11 April 2026

Response to EIS and Secretary's Environmental Assessment Requirements (SEARs)
State Significant Development; Build-to-Rent
607 Pacific Hwy Chatswood Dive Site

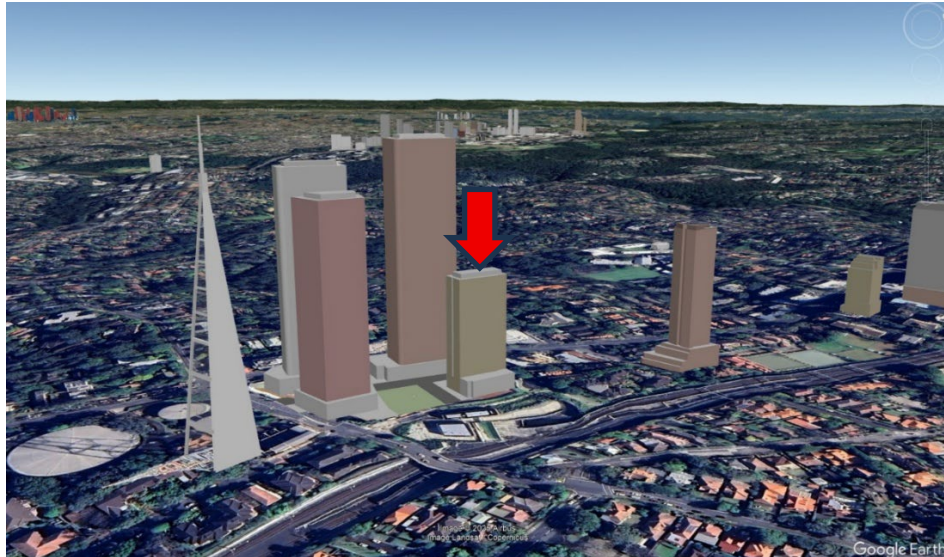
It clear that the BTR development (highlighted with a red arrow) within the Dive Site will be dwarfed by two other proposed developments on the site and along the Pacific Highway from St Leonards to Chatswood. All these developments should be incorporated in an all-encompassing SEARs/EIS evaluation
